KINGSTON STEAM PLANT				
PLAN OF BORROW INVESTIGATION				
TENNESSEE VALLEY AUTHORITY MATERIALS ENGINEERING LABORATORY				
SUBMITTED	RECOMMENDED	APPROVED		
KNOXVILLE	10-1775	36	CS	3 6048603A

Kingston Steam Plant - Ash Disposal Area Dikes  
Raising - Soils Investigation Report 11/3/75 and  
Evaluation

KINGSTON STEAM PLANT - ASH DISPOSAL AREA DIKE RAISING - SOIL INVESTIGATION

Kingston Steam Plant - Ash Disposal Area Dike Raising -  
Soils Report 11/3/75 - Evaluation

KINGSTON STEAM PLANT  
 FOUNDATION INVESTIGATION  
 BORINGS 1-8

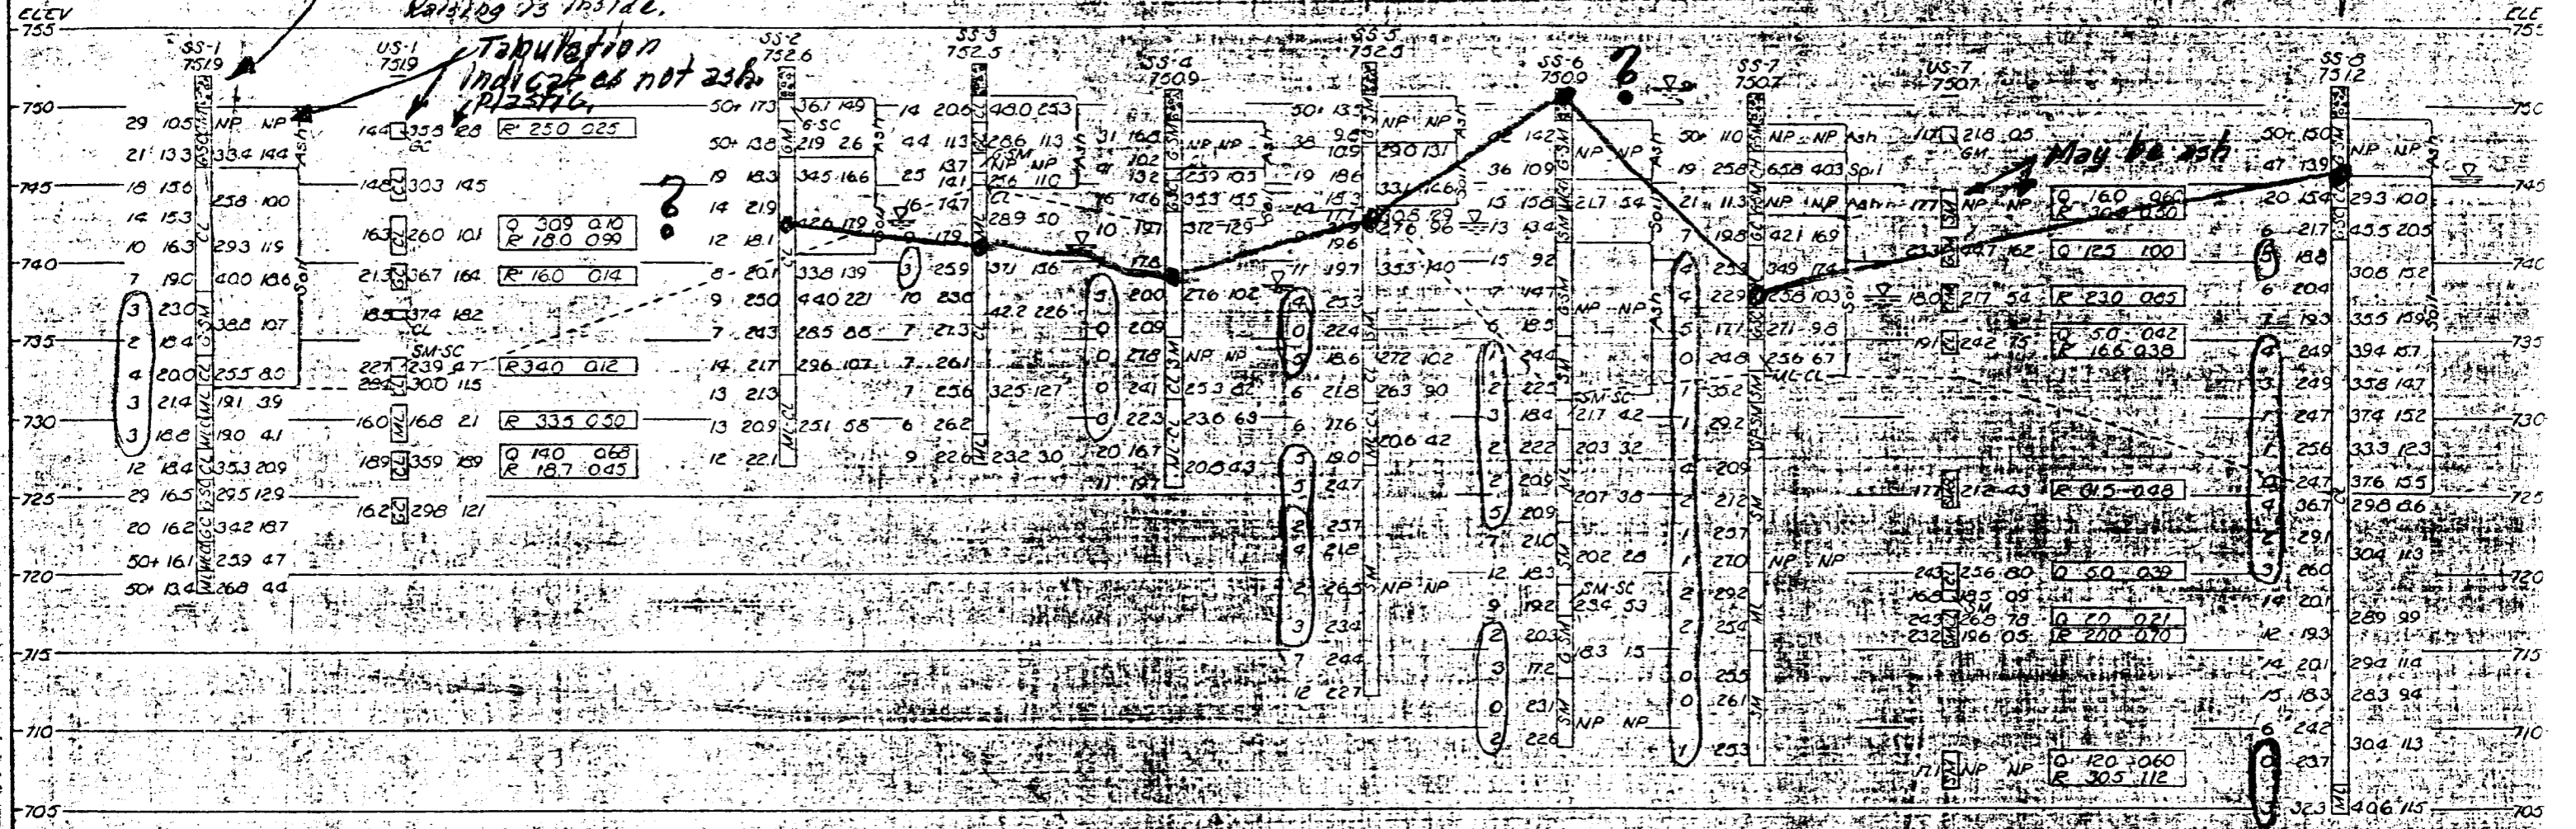
# Old DIKE C

top of dike 765

Waste spill of Ash  
 Vitrified to be removed  
 Don't need to remove on old dike  
 Raising is inside.

Borings 1-8 are  
 [This was supposed to be dike all of ash. It does not]

Tabulation  
 indicates not ash  
 Plastic

May be ash

Borings 1-8 are  
 Old DIKE C

KINGSTON STEAM PLANT  
 FOUNDATION INVESTIGATION  
 BORINGS 9-16

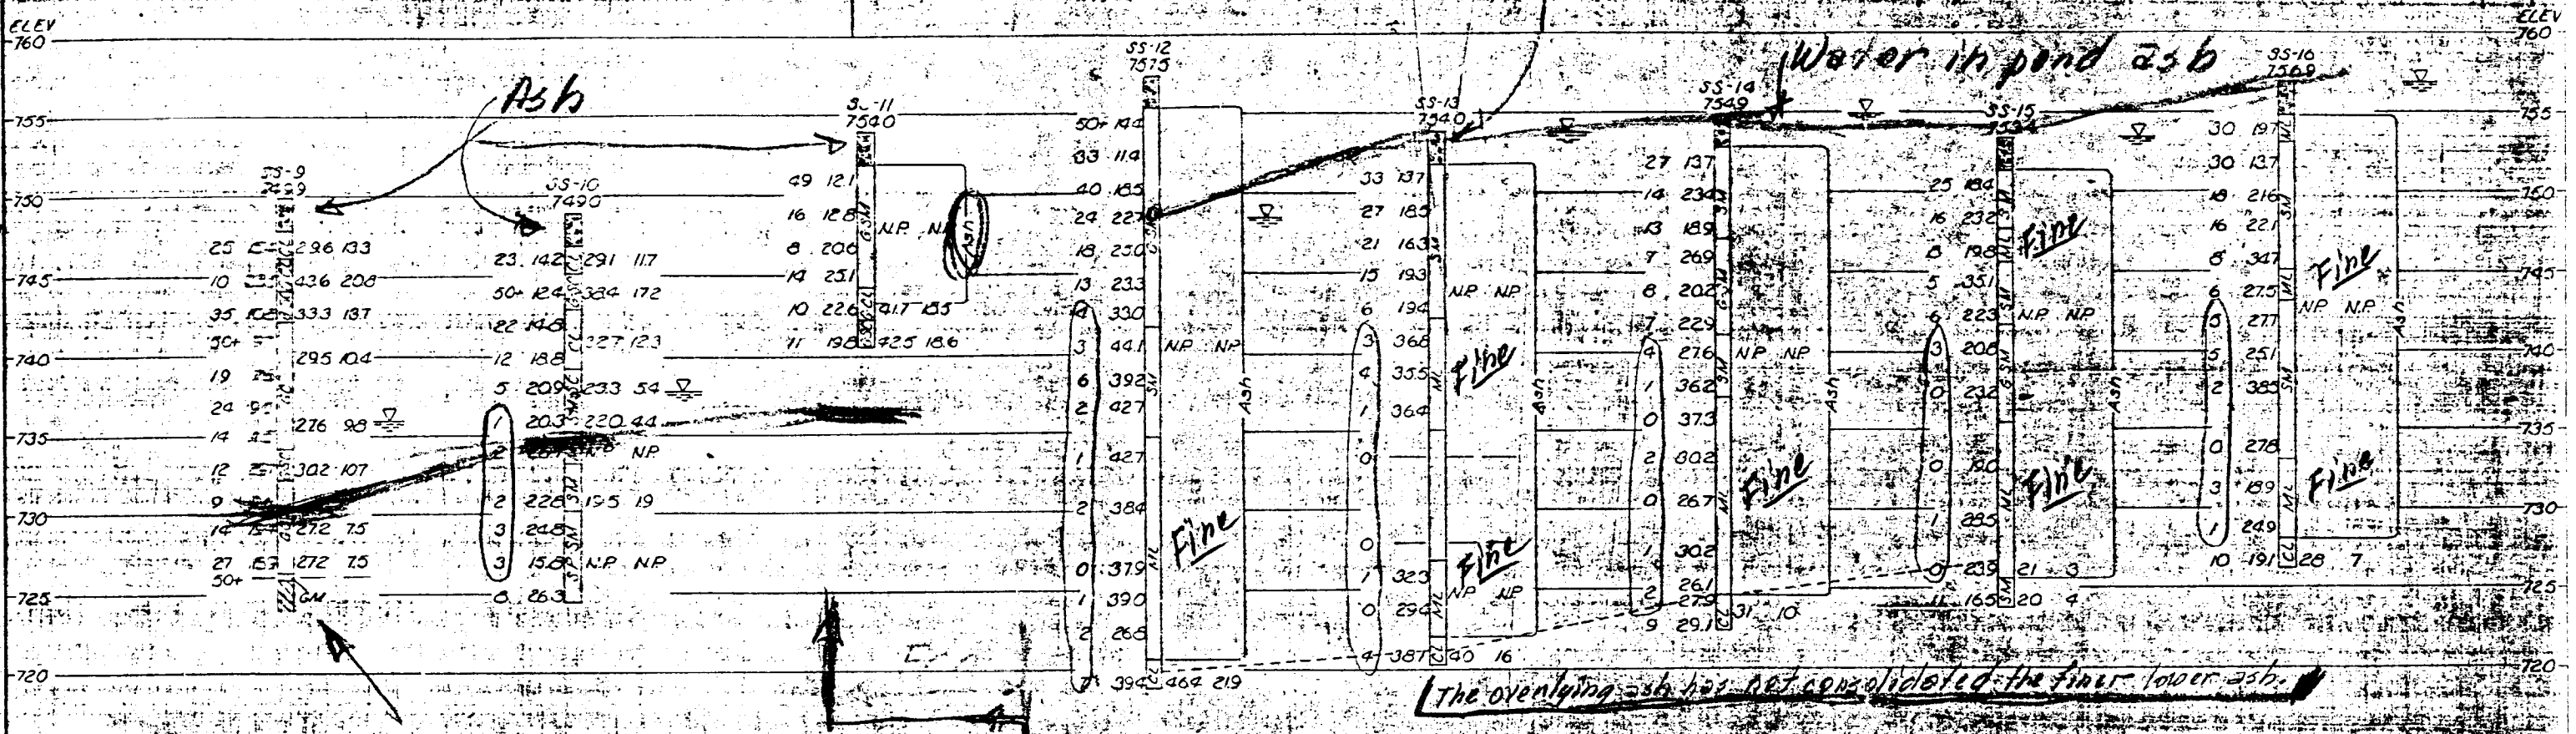
Way Road west of 1st St 746 ft  
 Water in this higher ash is  
 at top of ash. Does not drain  
 Ash symbols in ground...  
 It's all ash

Boring 5: not as deep as others. Strange.  
 Adjacent boring 8 was all soil, no ash.  
 Ground line & green marks are approx topo.  
 Holes 9, 10, since symbols say clay, it  
 is not ash which is symbol'd M, S M, etc.

This is the "dry haul"  
 disposal area inside  
 of old NORTH DIKE.

KINGSTON STEAM PLANT  
FOUNDATION INVESTIGATION  
BORINGS 17-24

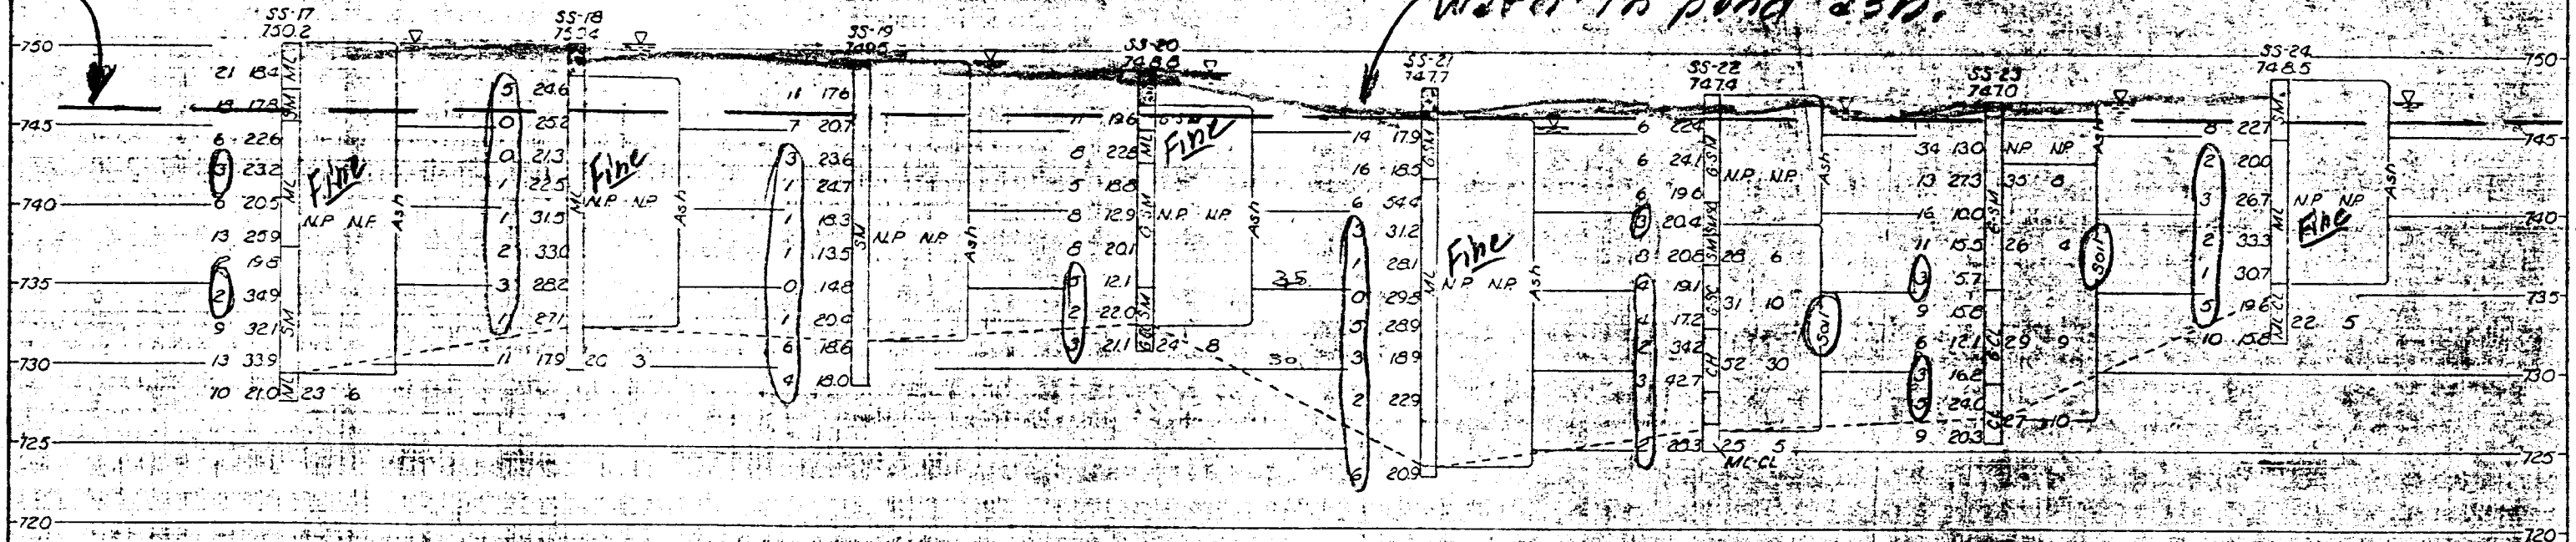
Ash inside  
old DIKE C

Ash inside  
old ROAD DIKE

Soil Request says borrow ash only above  
El 746. There is little. But request says take VD for  
density and strength in-situ. This was not done.

Water in pond ash.

These are borings  
of ash in pond  
along old DIKE C  
and ROAD DIKE

Not foundations  
Ash in pond.

KINGSTON STEAM PLANT		
BORROW INVESTIGATION		
AREA A		
BORINGS 1-9		
TENNESSEE VALLEY AUTHORITY		
MATERIALS ENGINEERING LABORATORY		
SUBMITTED	RECORDED	APPROVED
CR	WMB	R
KNOXVILLE	0-1775	36 CS 3 600460

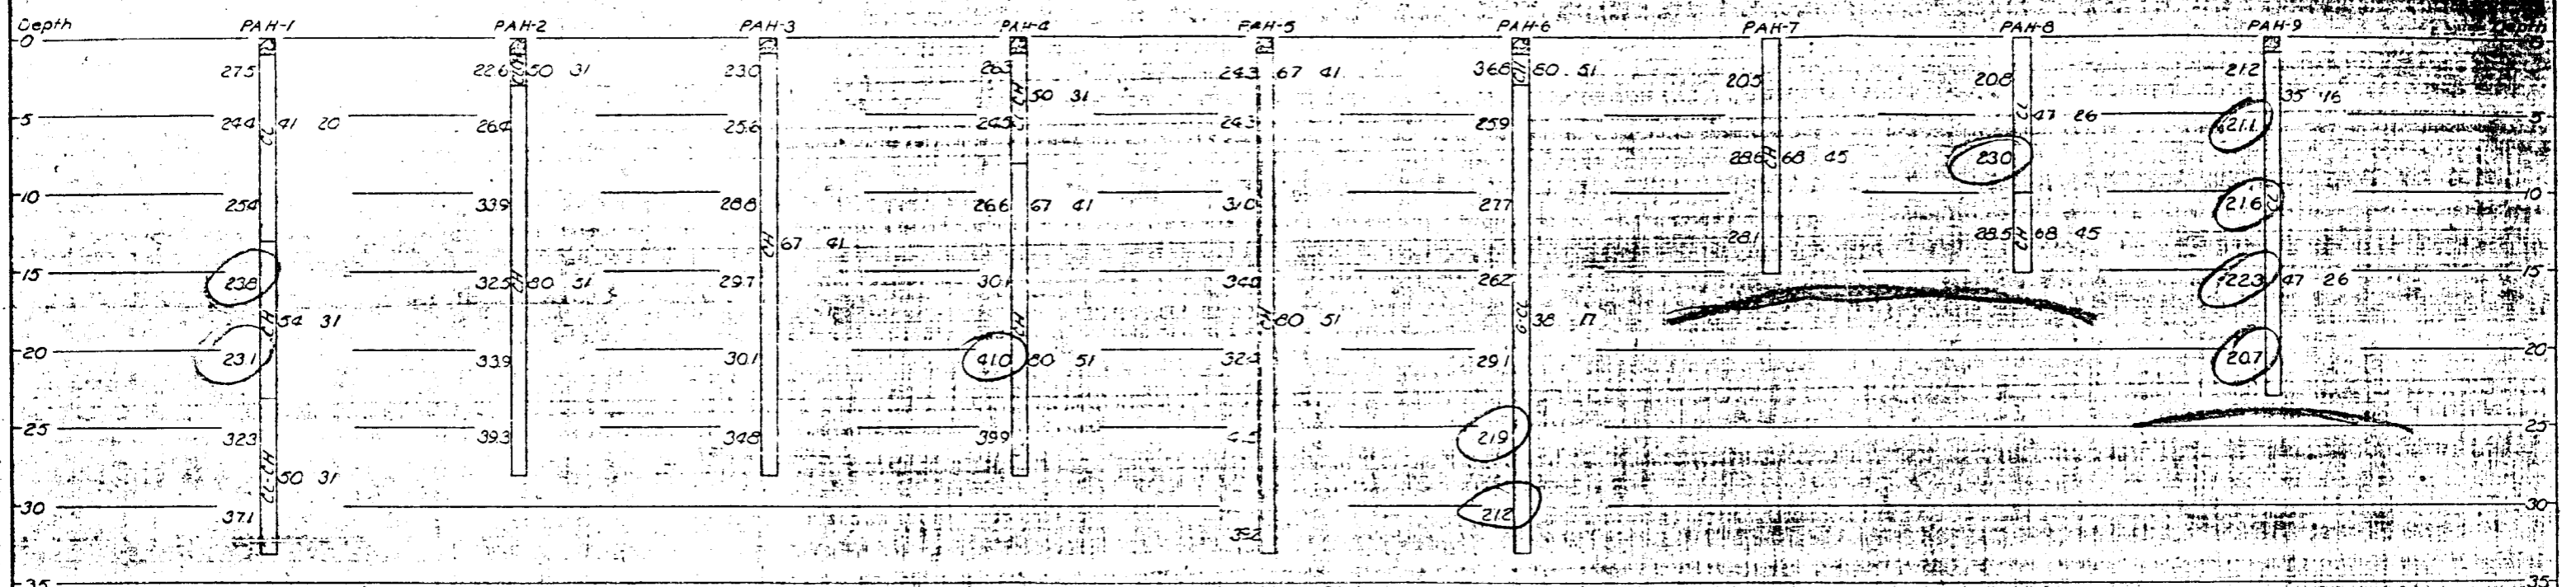
Plot is depth.  
 No indication of topo. re high and low areas  
 effect on moisture. CL + CH 30 probably little effect anyway.

No obvious stratification.  
 Moisture contents fairly constant.  
 Apparently generally drier than  
 Areas B & C.

Area A is apparently somewhat  
 less CH, and somewhat drier,  
 than Areas B + C.

Groundwater in borrow areas?

Classes III + IV CH  
 Opt moisture 25 to 30.  
 Classes I + II CL + sandy CH  
 Opt moisture 20 to 22.  
 Indicated in 3 also: Area A 15' plus to wet borrow.  
 Area B 20' " " " " " " " " " "  
 Area C, partly 10' " " " " " " " " " "

Phone with lab (Childress) 11/11/75  
 Effort was not made to locate groundwater as such.  
 The "high borings" were terminated  
 when soil became obviously wet.  
 Area B?

KINGSTON STEAM PLANT  
BORROW INVESTIGATION  
AREA B

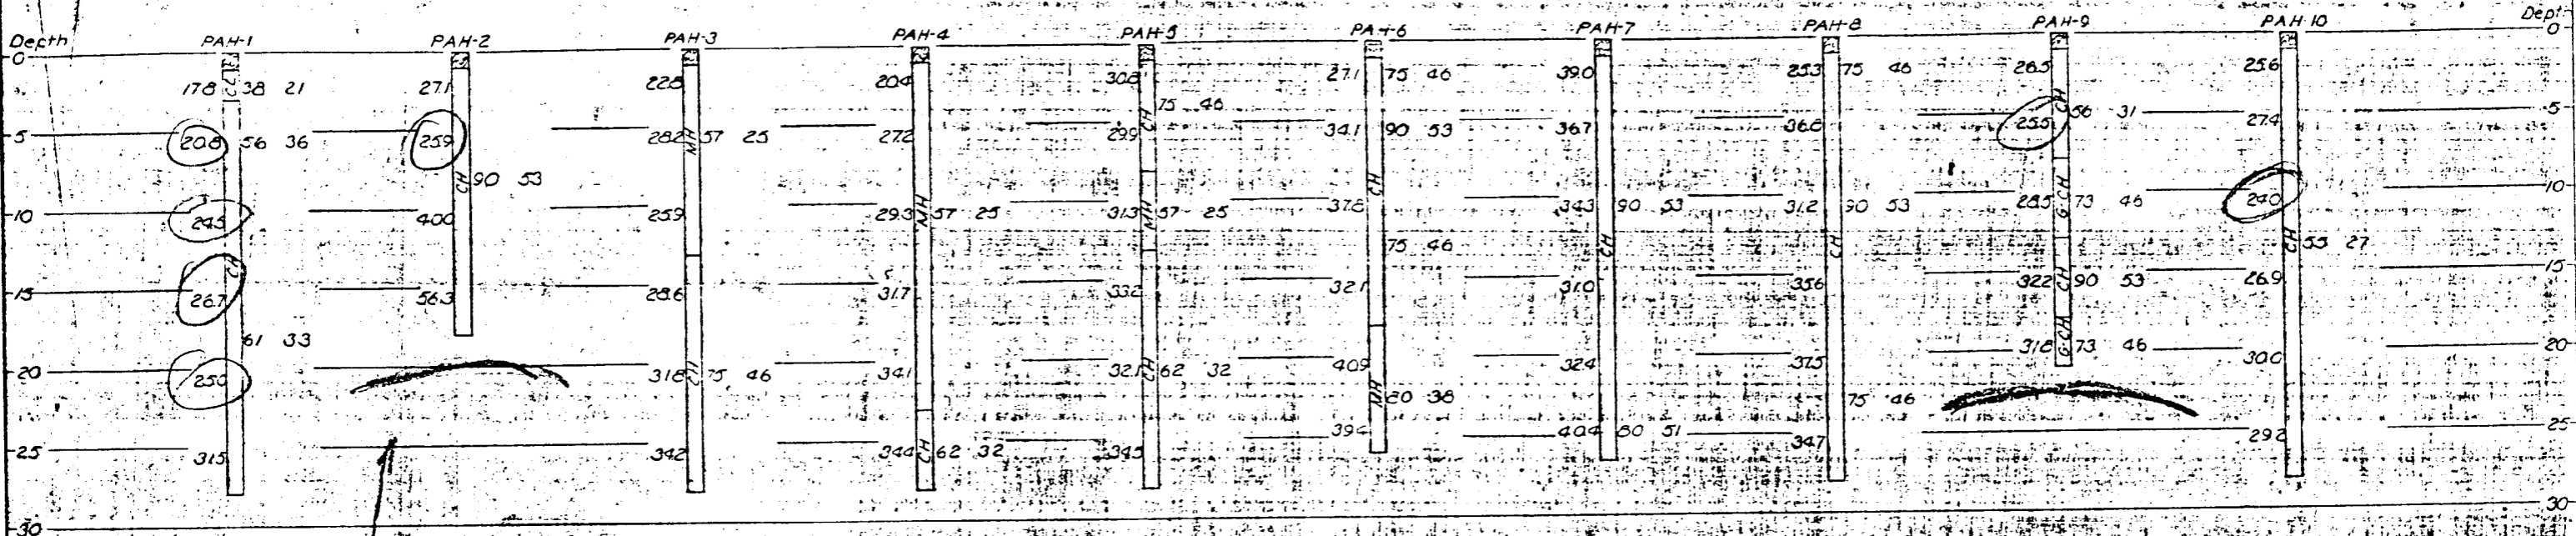
Groundwater?  
See log 607.

No obvious stratification.  
Mostly highly plastic CH  
Moisture contents fairly consistent  
Area A is less CH  
Area C is all CH and  
moisture variable.

KINGSTON STEAM PLANT			
BORROW INVESTIGATION			
AREA A			
BORINGS 10-15			
TENNESSEE VALLEY AUTHORITY			
MATERIALS ENGINEERING LABORATORY			
SUBMITTED	RECOMMENDED	APPROVED	
EMERYVILLE	07-75/36/35/3	04/26/08	04/26/08

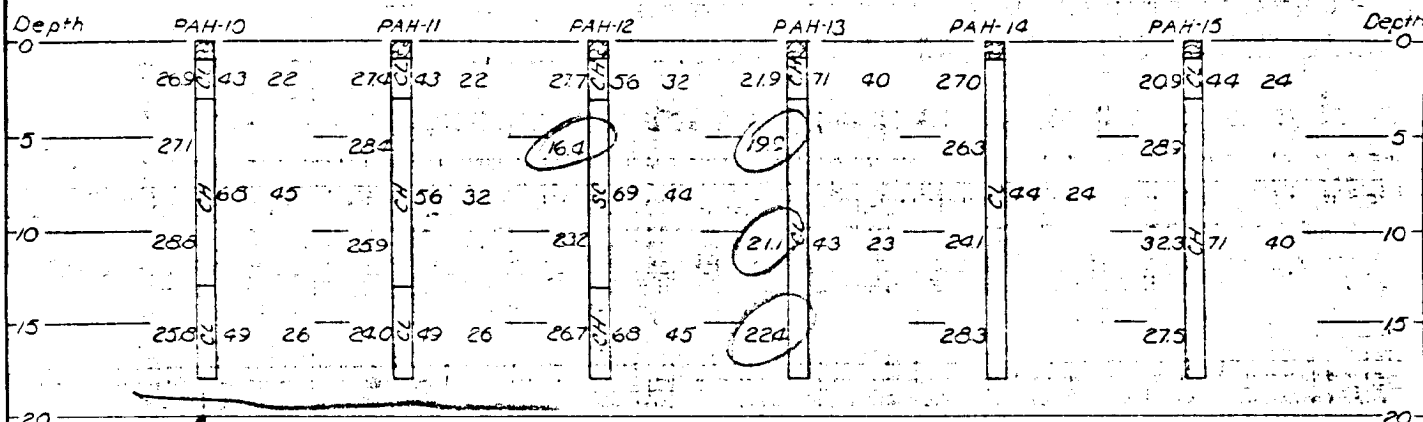
Groundwater?  
see dwg 607

No obvious stratification,  
moisture contents fairly  
consistent.

KINGSTON STEAM PLANT		
BORROW INVESTIGATION		
AREA C		
TENNESSEE VALLEY AUTHORITY		
MATERIALS ENGINEERING LABORATORY		
SUBMITTED	RECOMMENDED	APPROVED
EMERVILLE	10-17-73 36 CS	3 2043610RO

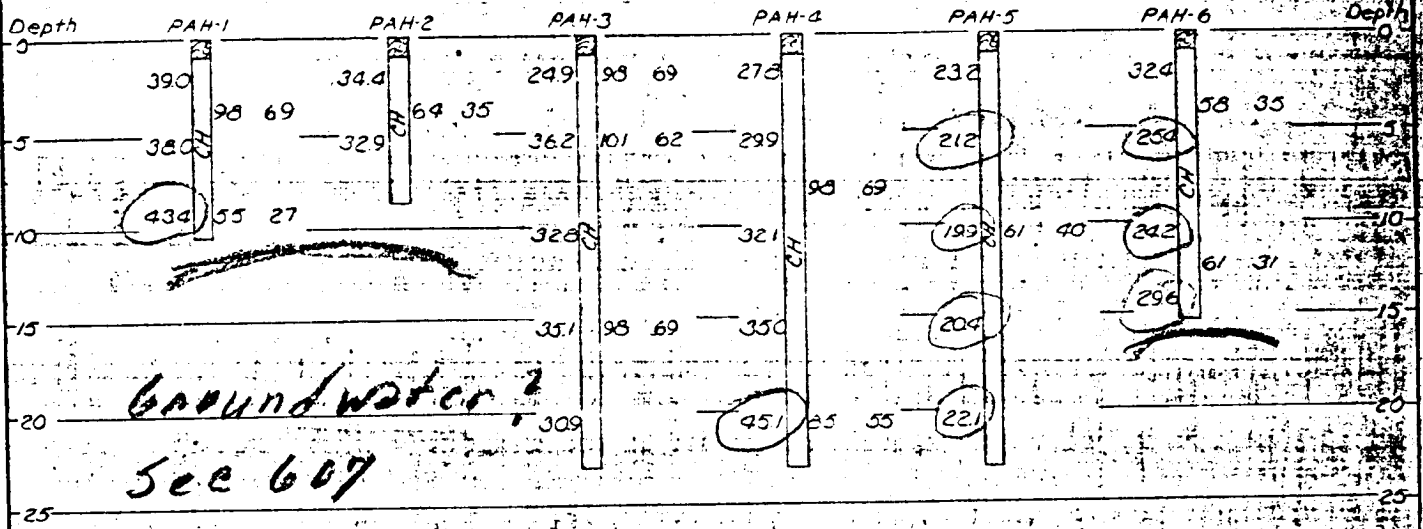
Groundwater?  
See 607

No obvious stratification  
All highly plastic CH  
Moisture contents variable  
Area A is less CH
